# Accessibility Compliance Report

Sydney 1 Project - Tower B  
1 Alfred Street, Sydney NSW

Client: Wanda Group  
Report: 152779.02 - Access  
Date: 26th October 2016

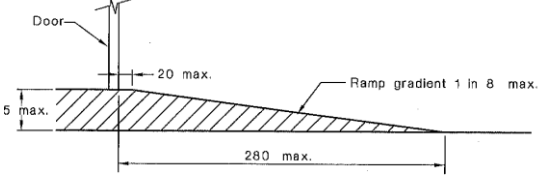
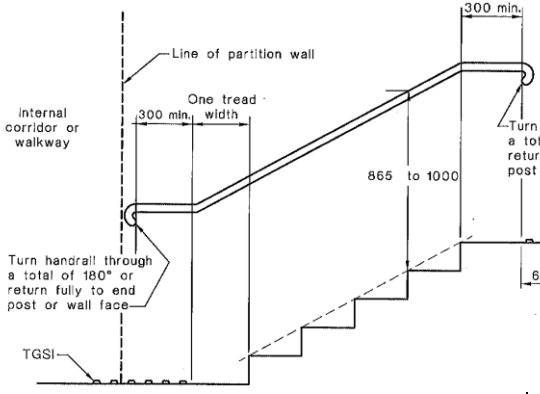
F2.4	Accessible sanitary facilities	<p>In a building required to be accessible, accessible unisex sanitary compartments must be provided in accessible parts of the building in accordance with Table F2.4(a).</p> <p><b>Class 3 Hotel</b></p> <p>In every accessible sole-occupancy unit and where male and female sanitary compartments are provided in common areas, not less than 1. Basement 3 level to be reviewed in detail at CC stage. An accessible is WC required and accessible changing room facilities.</p> <p><b>Class 6 Retail/Restaurants and 9b Function /Meeting rooms</b></p> <p>One on every storey containing sanitary facilities and where more than 1 bank of WC's provided, at not less than 50% of those banks.</p> <p>The WC facilities provided near the fitness café on Level 01 currently do not allow door circulation clearances leading to and from the accessible WC</p>	The building is capable of complying

BCA Clause	Title	Assessment and Comment	Status
		<p>and ambulant facilities not detailed within the male and female rooms. Sanitary facilities provided on all other levels within common areas of the hotel have not yet been detailed. Details to be reviewed within CC documentation.</p> <p>The sanitary facilities required for the retail tenancies will be designed at a later stage.</p> <p>The accessible unisex sanitary compartments must contain a closet pan, washbasin, shelf or bench top and adequate means of disposal of sanitary towels.</p> <p>The circulation spaces, fixtures and fittings of accessible sanitary facilities provided in accordance with Table F2.4(a) and Table F2.4(b) must comply with the requirements of AS 1428.1.</p> <p>In addition to the unisex sanitary compartment, each bank of toilets must be provided with a sanitary compartment suitable for a person with an ambulant disability in accordance with AS 1428.1 and must be provided for use by males and females. The facilities provided to the staff on Basement 3 level do not currently show ambulant toilets and will subject to a detailed review within construction documentation.</p>
